GEOTECHNICAL DESIGN AND MATERIALS REPORT
Vasco Road Safety Improvements
in Alameda County From MP 3.4 to MP 4.3

Prepared for:
County of Alameda
Public Works Agency
399 Elmhurst Street
Hayward, California 94544

Prepared by:
Cal Engineering & Geology
1870 Olympic Boulevard
Suite 100
Walnut Creek, California 94596

JOB NO. R23265 SPEC NO. 1903 JUNE 2001 FIGURE 4-2

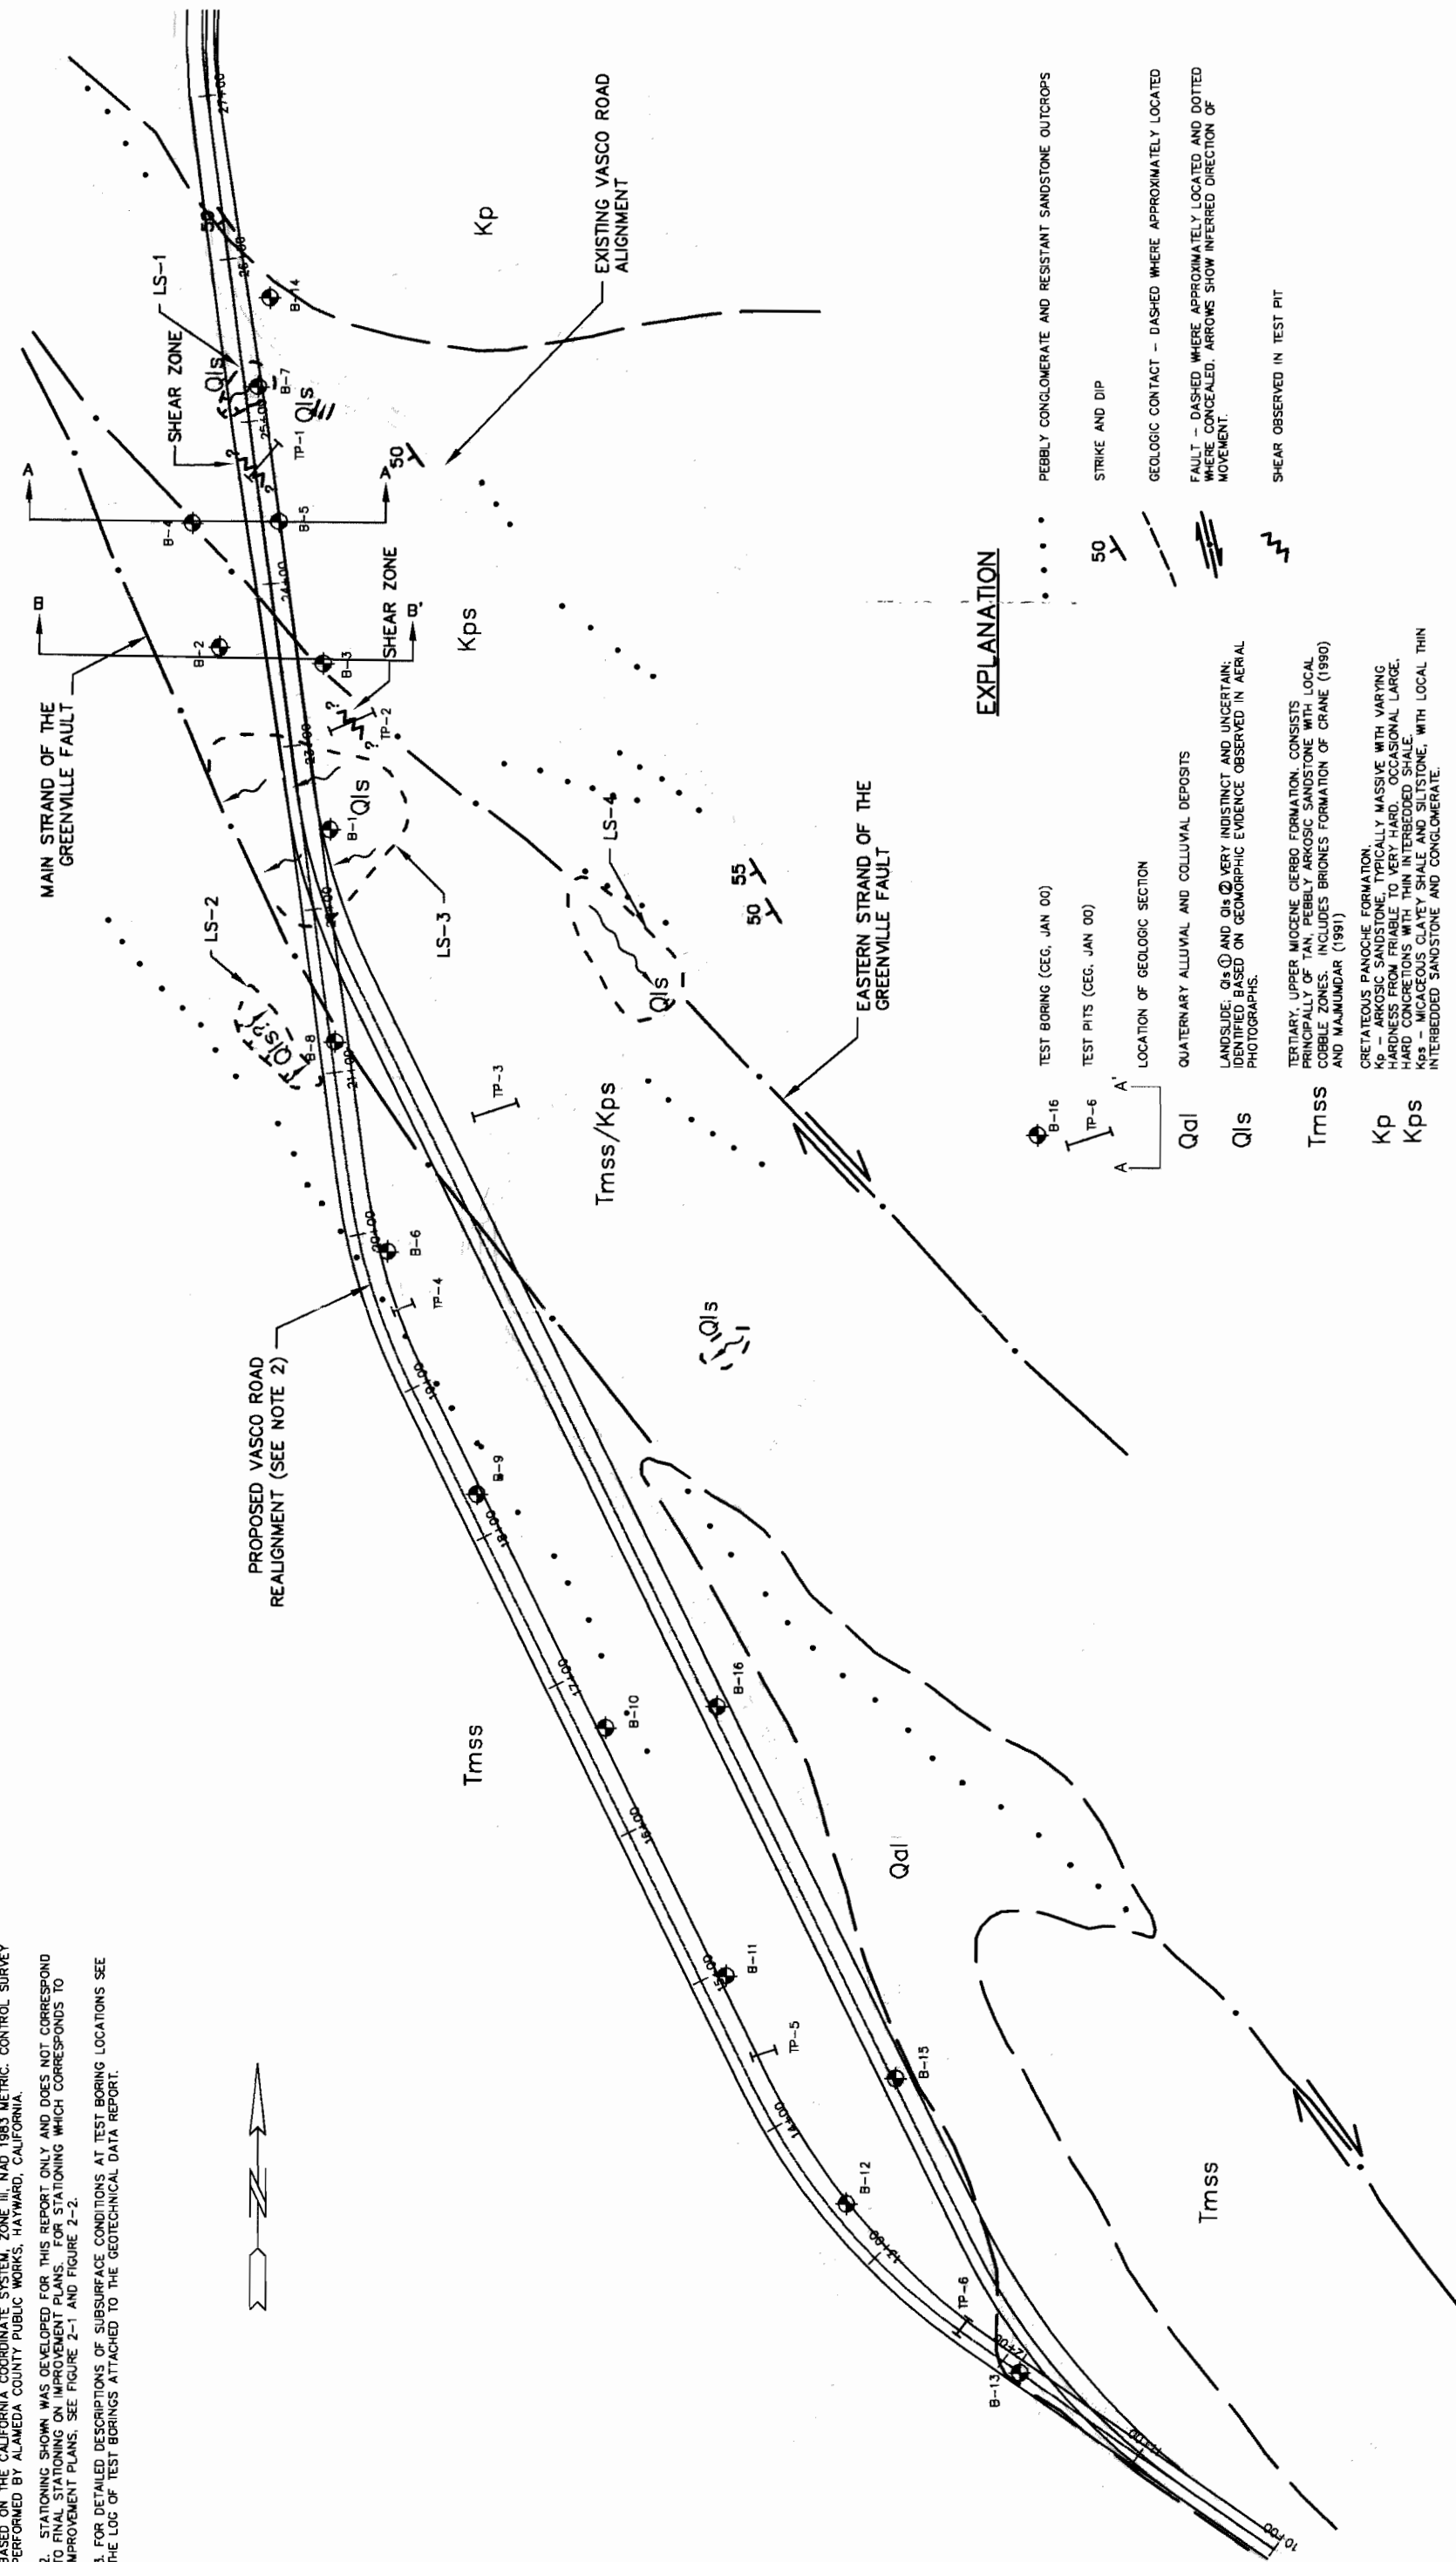
Figure 4-2

A legend, scale, north arrow, and box indicating the mapped area shown on Figure 4-3 should be added. Part of the legend can be handled by indicating that mapped units are as described in Section 4.4.1 of the report.

Figure 4-3 will be revised as recommended and included in the Final Geotechnical Design and Materials Report.

FIGURE 4-4

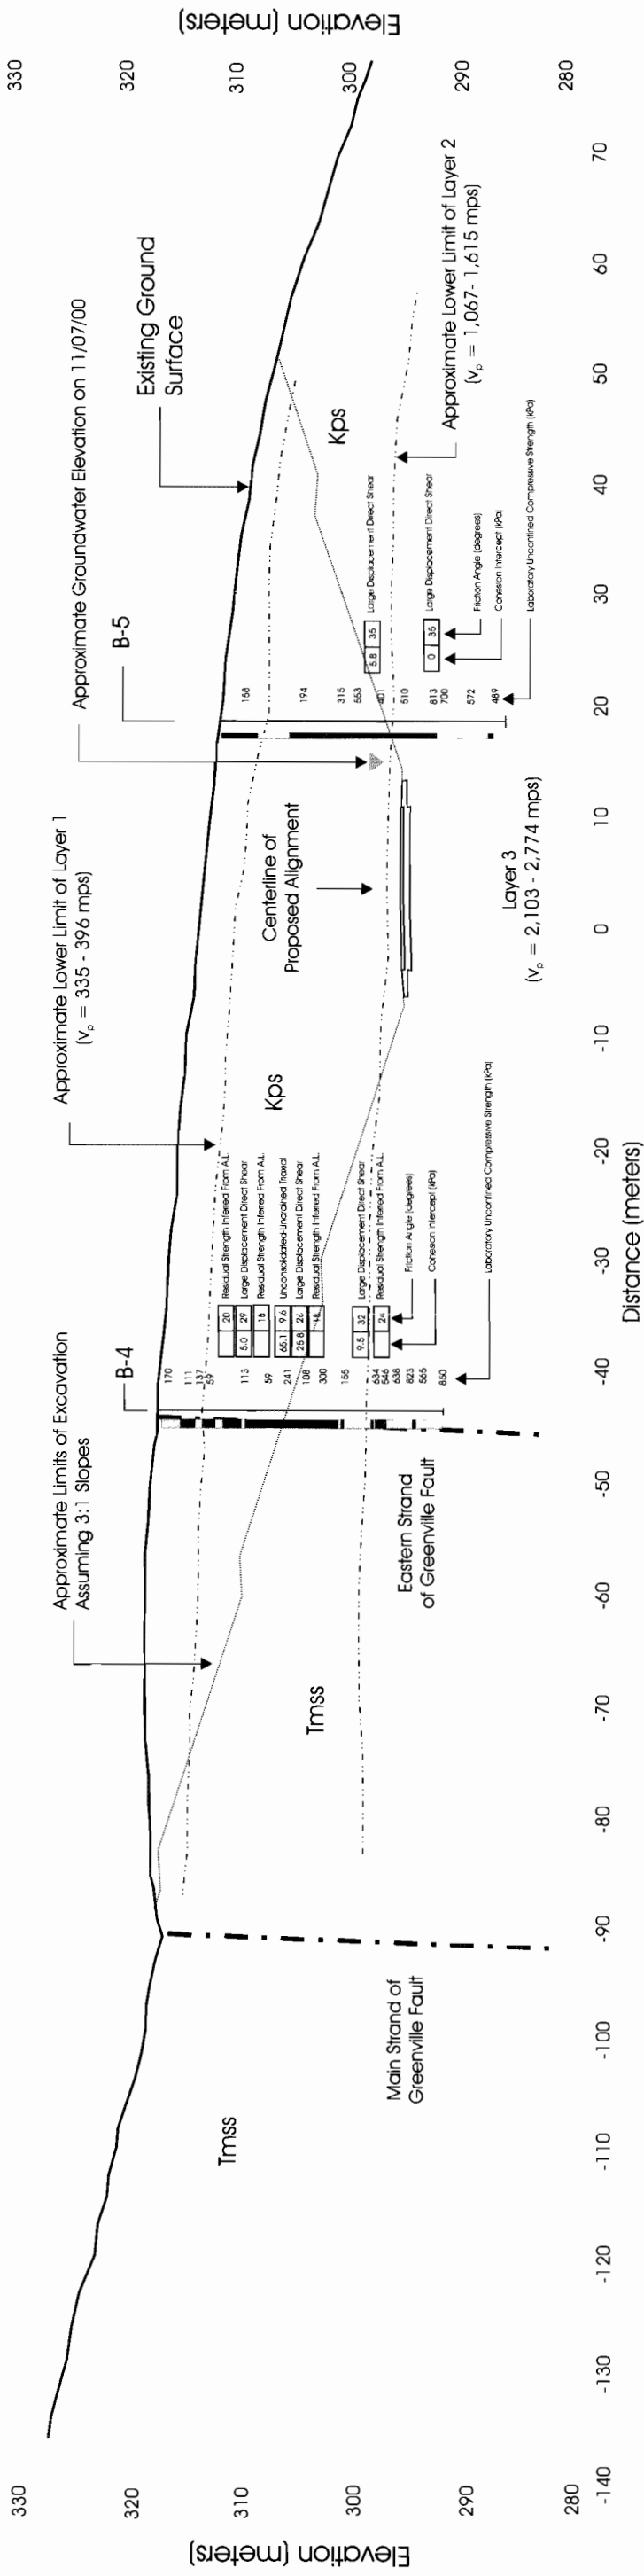
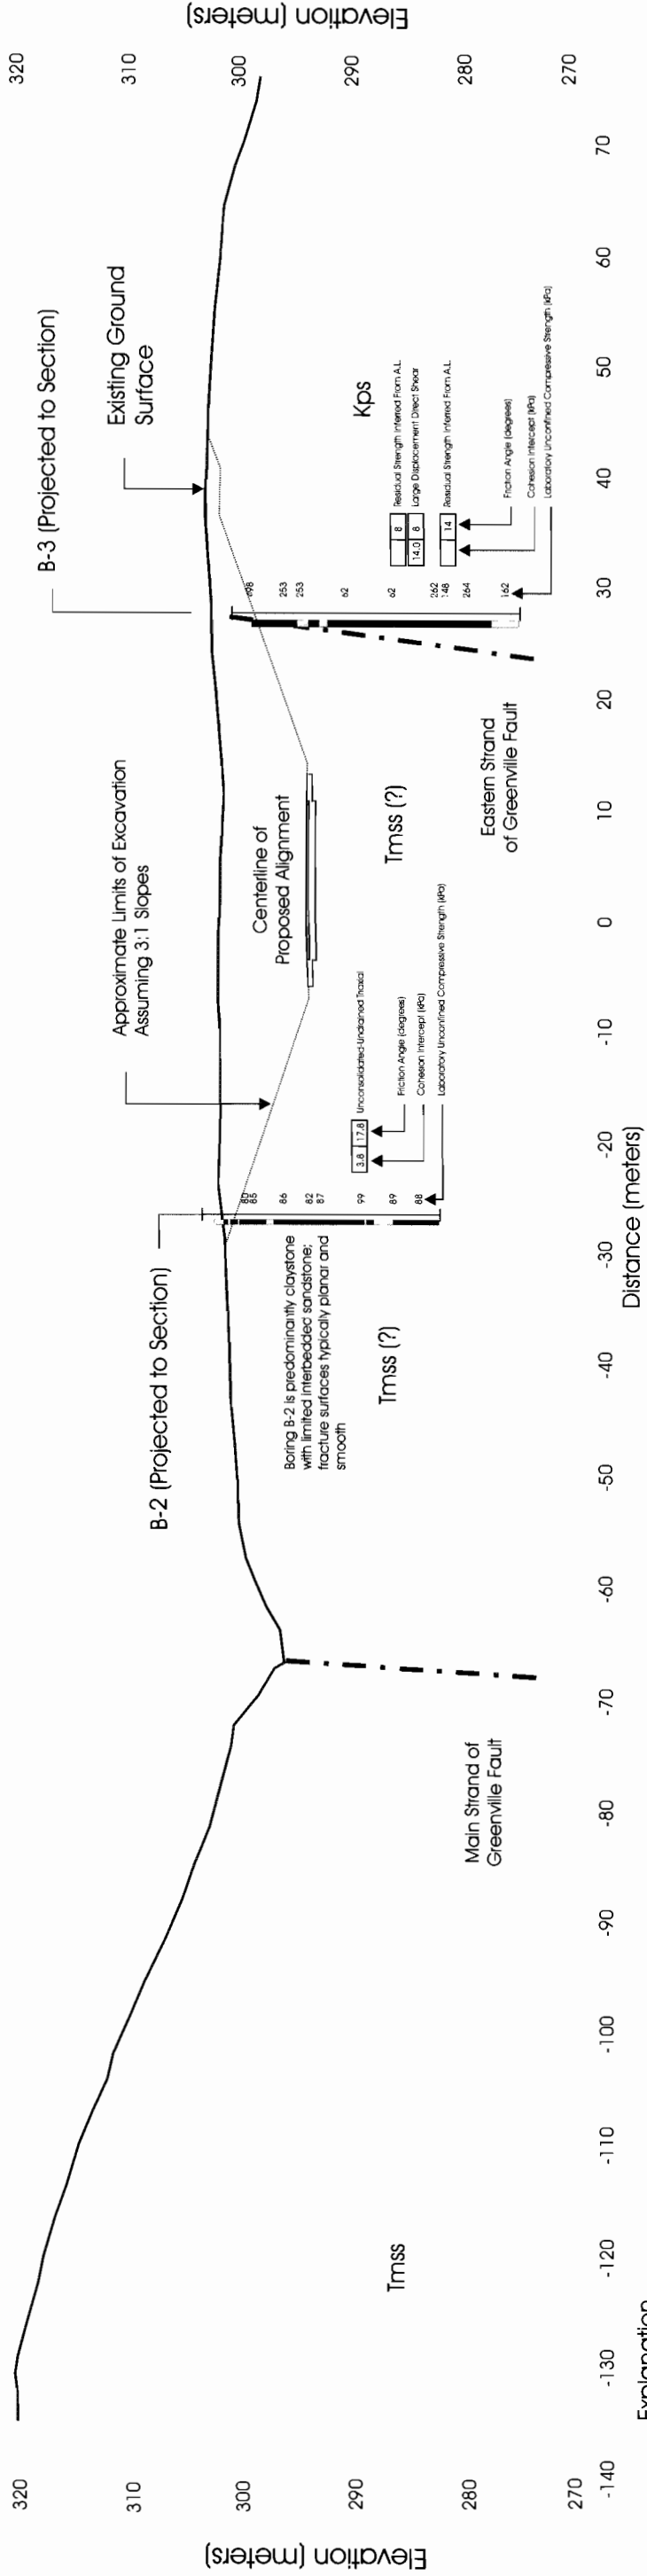
In Section 4.0, Physical Setting, Figure 4-4, the P-wave velocity identified in the figure is presented in terms of feet per second, which contrasts the metric report format and Section 8.2.2, Rippability, which discusses the P-wave velocity data in a metric format.

Also on Figure 4-4, the data presented for "Layer 2 ($V_p = 6900-9100$ fps)" should be corrected to identify this as Layer 3.

Sections lines shown on Figure 4-3 should be equivalent to the limits of the cross-sections shown on Figure 4-4.

Structural data provided on Figure 4-3 should be expressed in the cross-sections of Figure 4-4 (i.e., apparent dips). We anticipate that this would show that cut slopes would expose southwestwardly down-dipping bedrock (adversely oriented for cut slopes east of the centerline of the proposed alignment - i.e., westward-facing cut slopes).

Cal Engineering should discuss their extrapolation of results from the seismic refraction lines to cross-sections as shown on Figure 4-4 in consideration of the fact that the seismic refraction lines run perpendicular to the cross-section.

Figure 4-4 will be modified in the Final Geotechnical Design and Materials report to present P-wave velocities in metric format and to re-label the lowest seismic layer ($V_p = 6900-9100$ fps) as "Layer 3."

The lengths of the section lines in Figure 4-3 will revised to be consistent with the length of cross-section shown in Figure 4-4.

Section 5.3 of the Final Geotechnical Design and Materials Report will be revised to include metric distances for the seismic refraction lines. Section 5.3 will also be revised to reference Figure 4-4 and to note that the seismic refraction data shown in this figure is extrapolated from refraction lines that were laid out normal to the cross section locations.
